EIA Report Addendum

Drumduff Extension Wind Farm

Volume 1: Further Environmental Information

Drumduff Extension Limited

Figure 1: Turbine and Receptor Locations

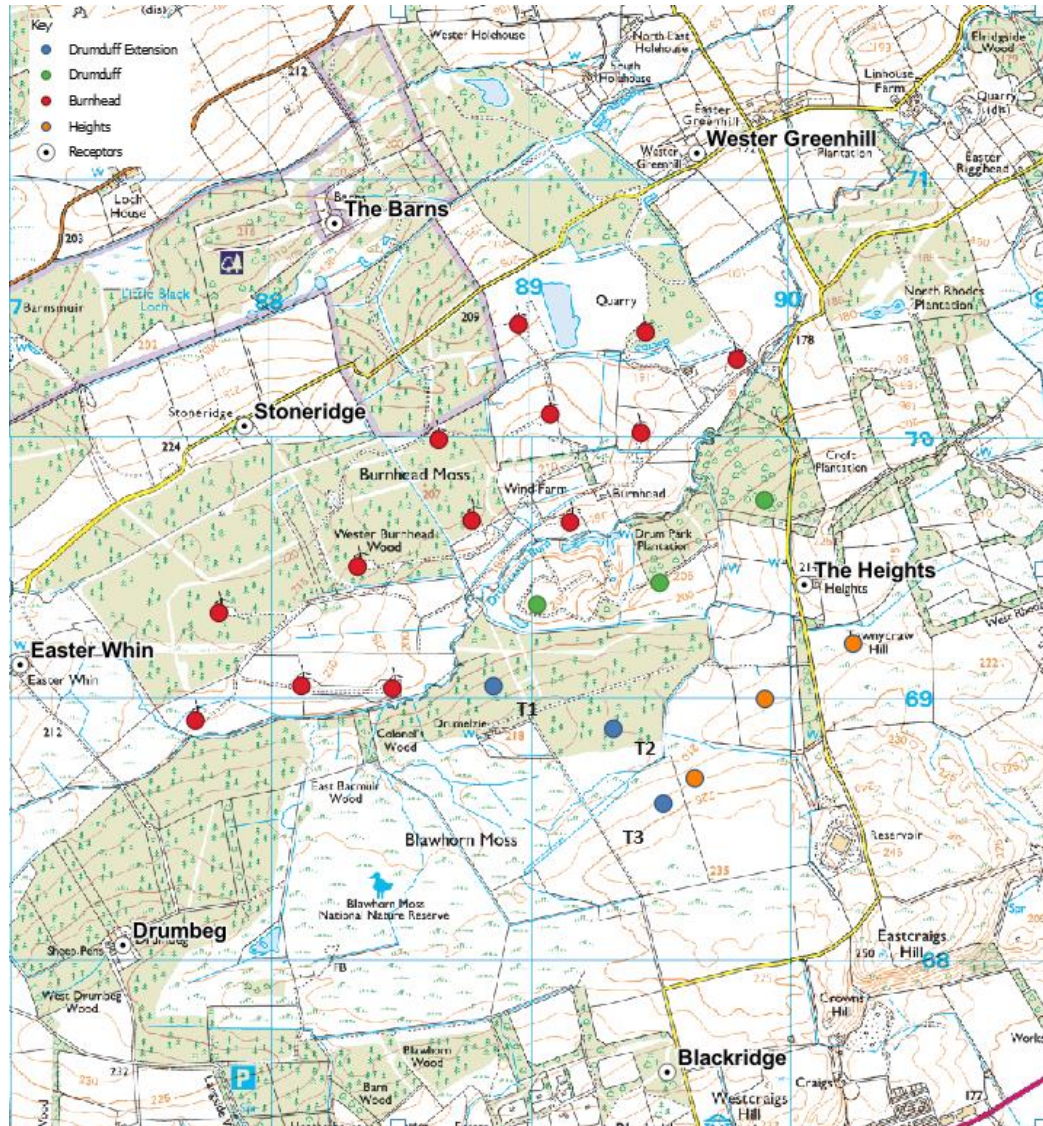
* The Heights property is understood to have been taken out of residential use and is not considered any further in this assessment.

The closest residential property in Blackridge has been assumed to be that covered by planning application 1142/FUL/22, Land South of Beechbrae Woodland Centre, which was recently consented.

Figure A1-2
Site Layout

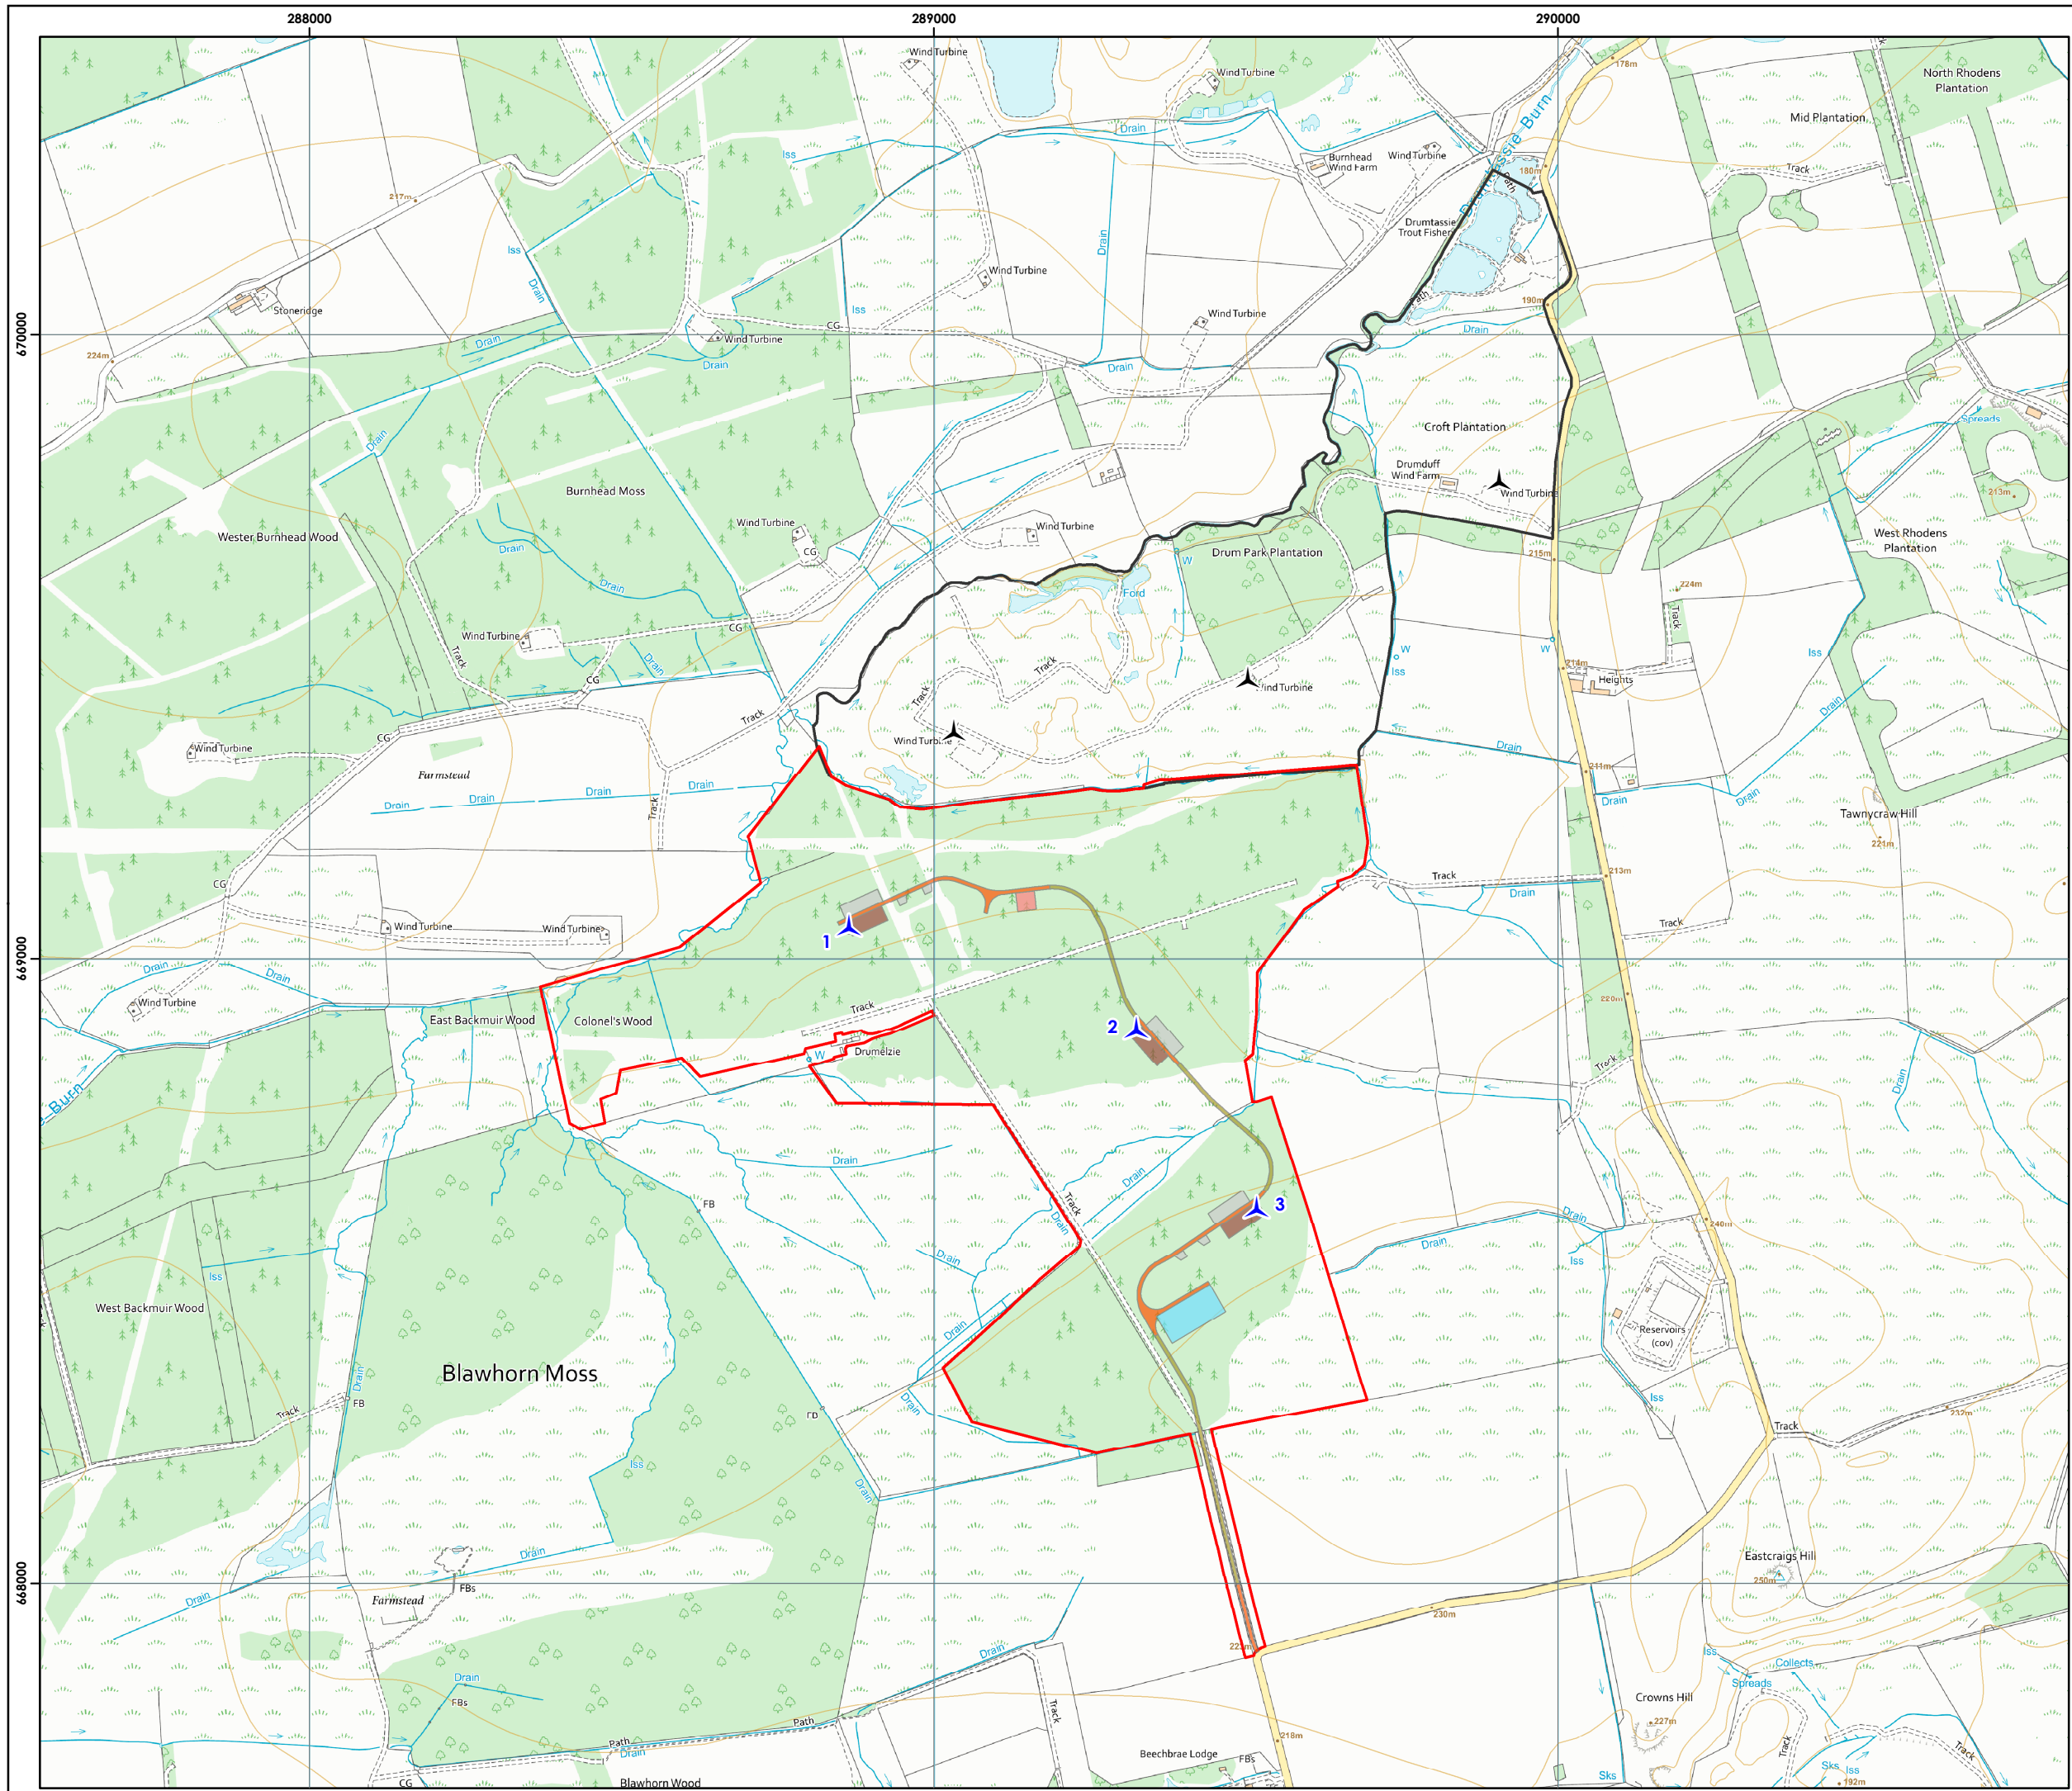
The amendments to the infrastructure detailed in section 2.2 and 2.3 are presented in an updated Figures A1-2 Site Layout and Figure A8-4 Interpolated Peat Depth. This new layout (Appendix A of this addendum) supersedes the previous version submitted as part of Volume 4a of the EIA for the Proposed Development.

In response to this, the Applicant has revised the infrastructure, specifically the access tracks between T2 and T3 – the updates of which are presented in Section 2.3. With the removal of two crane boom hardstandings within the peat body and the revision to the length and areas of floating track (as presented in Appendix A, Figure A8-4 Interpolated Peat Depth), it is expected that, from a hydrological perspective, the integrity of the peat body within the site boundary is very unlikely to be subject to significant effects due to the lack of direct hydrological connectivity between the two. Therefore, the likelihood of impact on the peat body within the SAC due to direct hydrological effects is very unlikely. The proposed infrastructure layout was designed to avoid any upgrade works to the existing track that directly borders the Blawhorn Moss SAC.
